Project Description	Single Family Residential Subdivision in an R-5 Zoning District consisting of 37 lots.
Name of Subdivision	Pinehurst South Cottages

PINEHURST SOUTH COTTAGES

To: Planning and Zoning Board
From: Alex Cameron, Senior Planner
Cc: Darryn Burich, Director of Planning and Inspections
Kelly Brown, Planning Administrative Specialist and Clerk to the Board
Date: September 25, 2020
Subject: Staff Report for Proposed Pinehurst South Cottages Major Subdivision

TYPICAL STREET SECTION

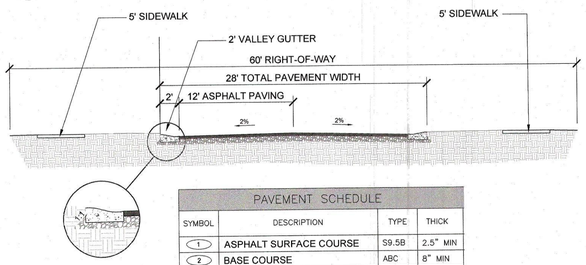
6. Please add a note to the Typical Street Section on L-1 requesting the waiver to utilize 2-foot concrete valley gutter in lieu of the Village's standard of 24-inch curb and gutter.

PRELIMINARY PLAT PLAN

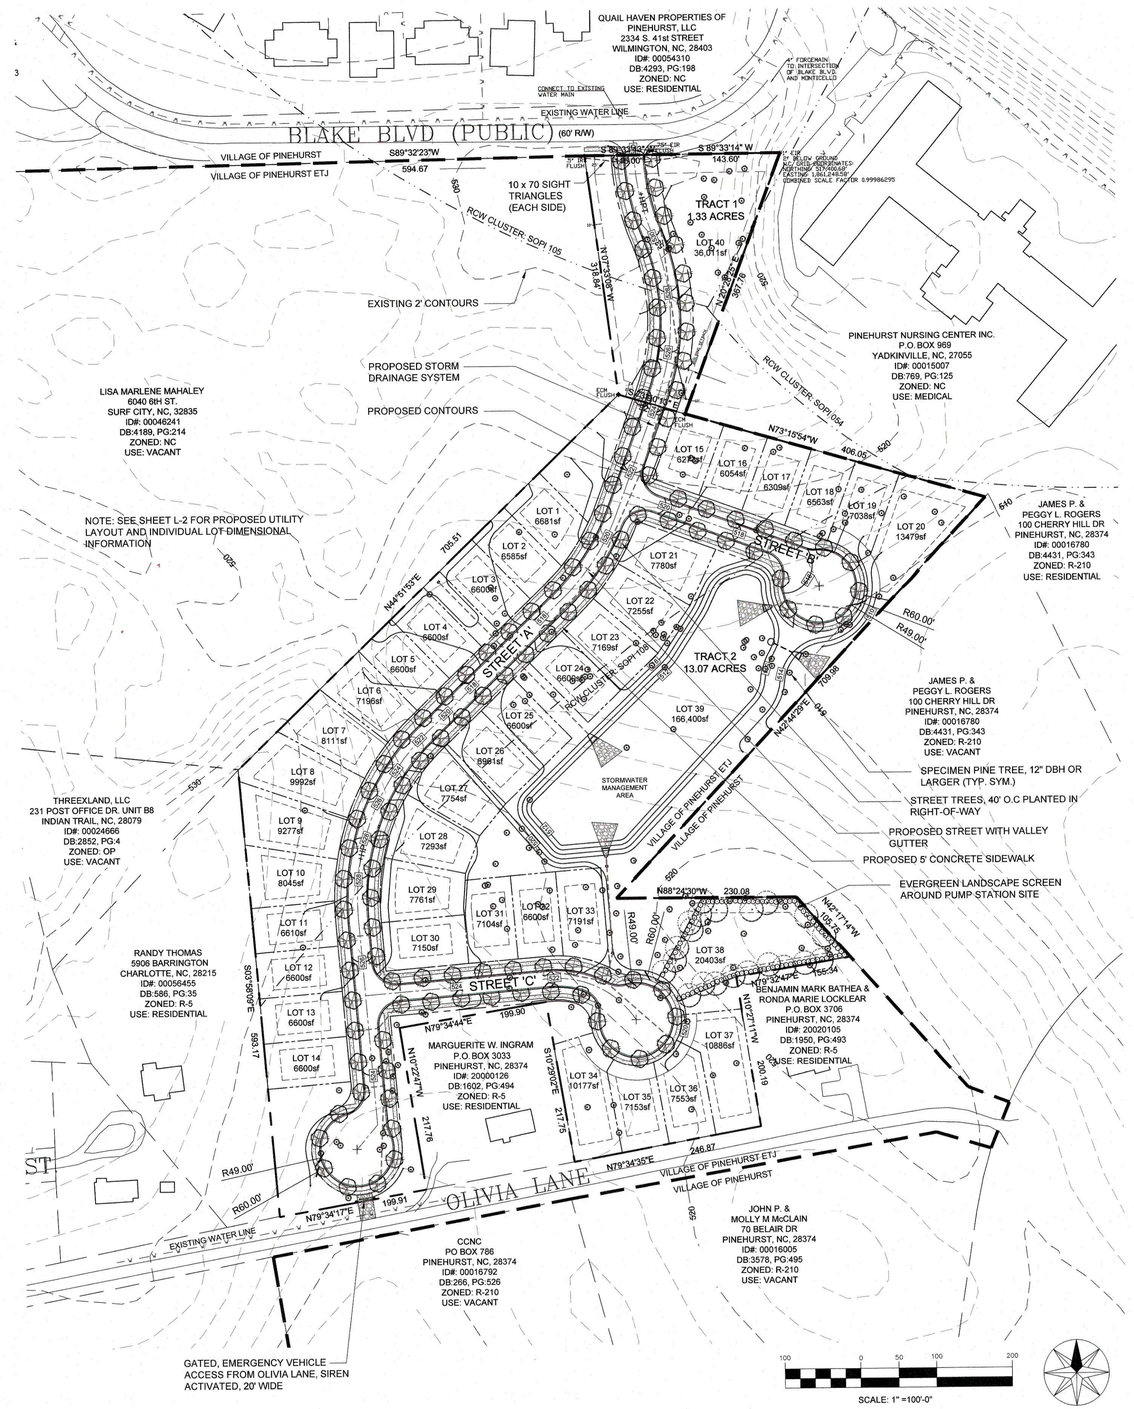
- Recommend reserving right-of-way at the southern cul-de-sac and to adjacent properties to provide for continuation/extension of streets in the Olivia Road and Arnette Street area to comply with Section 9.17.1.15 (B) of the PDO.

- Block length for western block appears to exceed the PDO maximum length of 1,000 feet (applicant disagrees with staff interpretation)
- Provide an updated RCW letter or assessment.

6. Per Section 9.17.1.15 (B) reserve right-of-way at southern cul-de-sac to provide for continuation or extension of principal streets in the area to Olivia Rd. and Arnette Street. This would be in line with good land planning practices and as the Railroad looks to abandon one of the crossings in the area, (Olivia Rd.) would allow and provide access to Arnette St. in the future.

2. Response to previous Comment #2 indicates that a sight triangle easement is not anticipated to be necessary at the connection to Blake Boulevard. Please clarify, as the 10' X 70' sight triangle easement is part of the Village's adopted standards and the triangle shown on the plat extends off of the parcel. How will the standard be met without an easement?

4. Response to previous Comment #4 did not address the question regarding maintenance responsibilities for the pipe between Lots 3 and 4. We presume that this pipe will be maintained by the HOA, but please clarify. Note that the Village will only maintain the portions of pipes within the public right-of-way, and per Section 5 of the ESSM, a manhole or junction box will be required at the transition from the public right-of-way boundary. In addition, please clarify the response to Comment #4 that "any discharge of the adjoining site that is conveyed to our stormwater management device will be allowed to pass un-detained." Full compliance with the ESSM stormwater requirements must be demonstrated during the construction document phase.
